SHEARON HARRIS NUCLEAR POWER PLANT
NRC DOCKET NO. 50-400/LICENSE NO. NPF-63
REQUEST FOR LICENSE AMENDMENT
REACTOR COOLANT SYSTEM (RCS) FLOW RATE

TECHNICAL SPECIFICATION PAGES

Figure 3.2-3

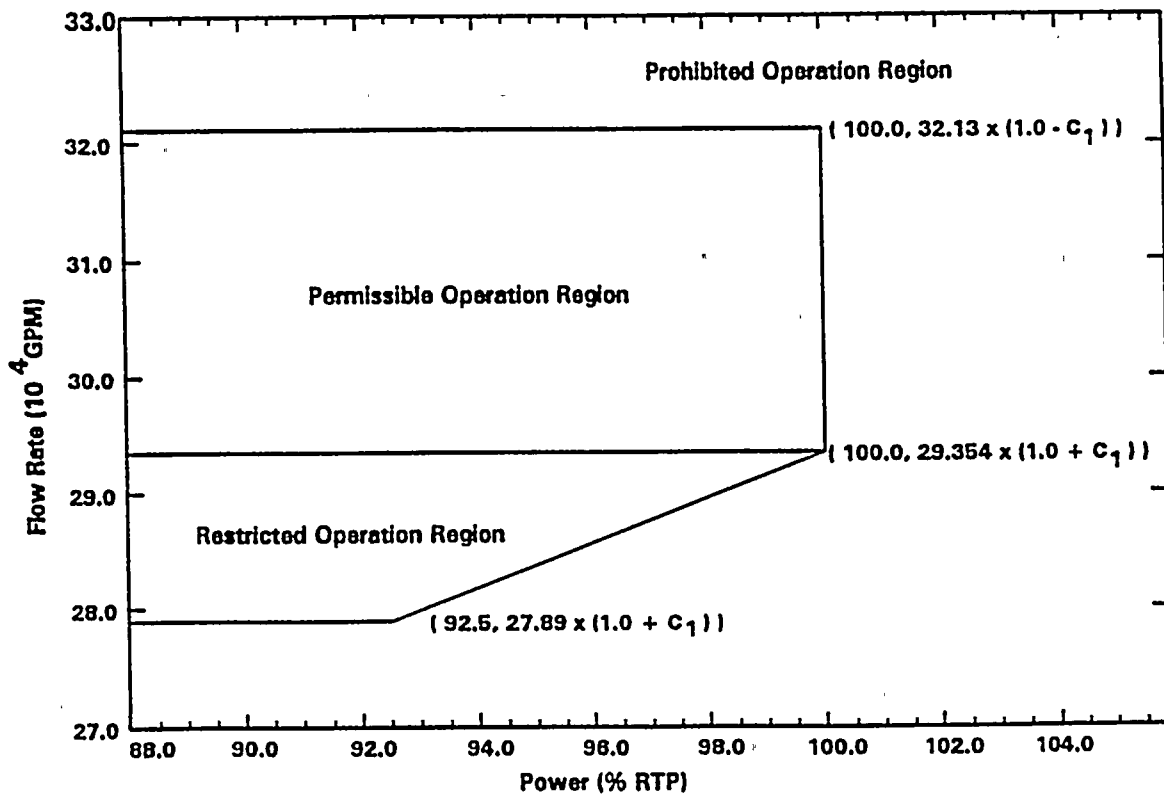
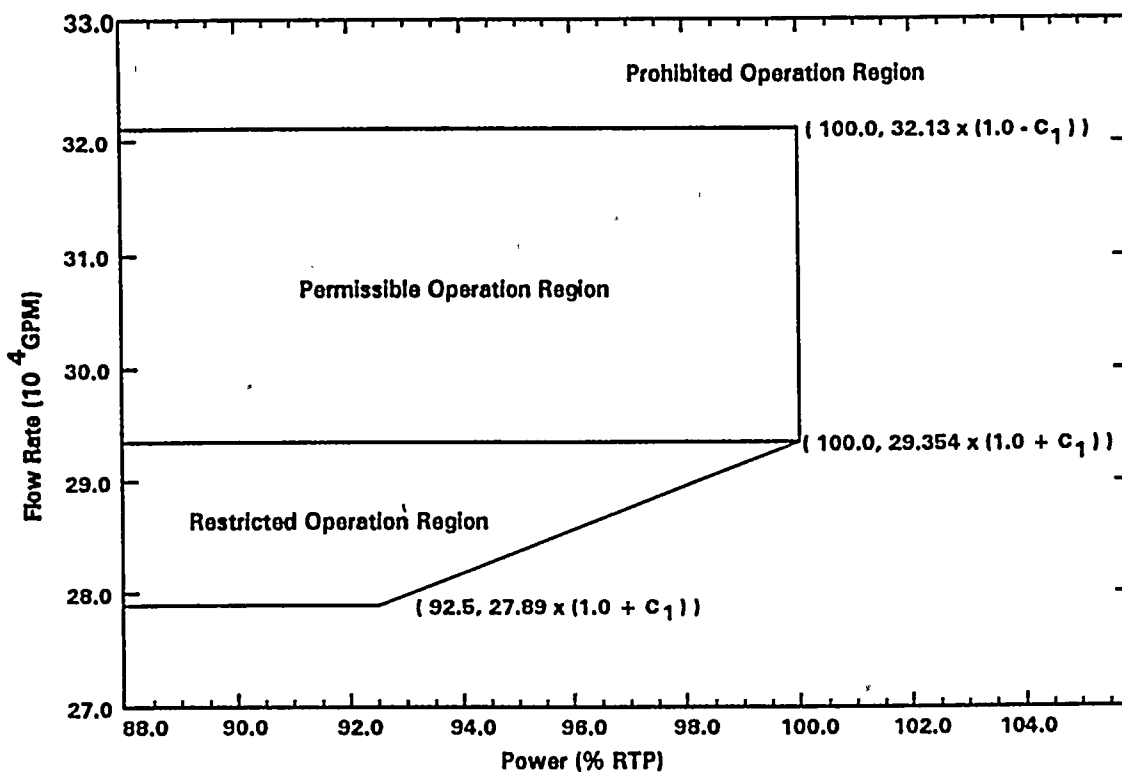
3.2.3 The combination of indicated Reactor Coolant System (RCS) total flow rate and THERMAL POWER shall be maintained within the region of permissible operation shown on Figure 3.2-3 for three loop operation and $F_{\Delta H}$ shall be maintained as follows:

- a. With the combination of RCS total flow rate and THERMAL POWER within the region of prohibited operation shown on Figure 3.2-3 or $F_{\Delta H}$ outside the limits given in 3.2.3a.:
1. Within 2 hours either:
 - a) Restore the combination of RCS total flow rate and THERMAL POWER to within the region of permissible operation, and $F_{\Delta H}$ to within the limits given in 3.2.3a., or
 - b) Restore the combination of RCS total flow rate and THERMAL POWER to within the region of restricted operation and comply with ACTION b. below, or

- b. With the combination of RCS total flow rate and THERMAL POWER within the region of restricted operation (flow rate less than $[293,540 \text{ gpm} \times (1.0 + C_1)]$, which includes measurement uncertainty for core flow, C_1 , as described in the Bases), within 6 hours reduce the Power Range Neutron Flux-High Trip Setpoint to below the nominal setpoint by the same amount (% RTP) as the power reduction required by Figure 3.2-3 and maintain $F_{\Delta H}$ at a value that is less than or equal to the value of $F_{\Delta H}$ at RATED THERMAL POWER.

- c. Within 24 hours of initially being within the region of prohibited operation shown on Figure 3.2-3 either:
1. Verify through RCS total flow rate determination and incore flux mapping that the combination of RCS total flow rate and THERMAL POWER are restored to within the region of permissible operation, and $F_{\Delta H}$ to within the limits given in 3.2.3a., or

New Figure

$F_{\Delta H}$ will be maintained within its limits provided Conditions a. through d. above are maintained. The combination of measured RCS flow rate and THERMAL POWER must be maintained within the regions of permissible or restricted operation as shown in Figure 3.2-3 to ensure that the combination of RCS flow rate and THERMAL POWER are within the ranges considered in the mechanical and safety analyses and, along with the measurement of $F_{\Delta H}$, to ensure that the calculated DNBR will not be below the design DNBR value. The relaxation of $F_{\Delta H}$ as a function of THERMAL POWER when in the region of permissible operation allows changes in the radial power shape for all permissible rod insertion limits.

For the FSAR Chapter 15 analyses reliant on the Power Range Neutron Flux - High Trip Setting trip function, reduction of the Setpoint by the same percentage as the required power reduction in Figure 3.2-3 (1.5% RTP per 1% RCS flow rate) ensures DNBR margin is maintained. When in the region of restricted operation, defining ΔT_0 as the equivalent ΔT at 100% RTP and $[293,540 \text{ gpm} \times (1.0 + C_1)]$ (which includes measurement uncertainty for core flow) results in an effective $OT\Delta T$ setpoint reduction and maintains DNBR margins for those analyses reliant upon the $OT\Delta T$ trip. The additional restrictions on $F_{\Delta H}$ when in the region of restricted operation ensure that the margins gained by the power and setpoint reductions are not reduced by the normally allowable increases in radial peaking at reduced power levels.

The upper limit on measured RCS flow rate in Figure 3.2-3
[321,300 gpm x (1.0 - C₁)] protects the mechanical design flow of 321,300 gpm per
FSAR Table 5.1.0-1.
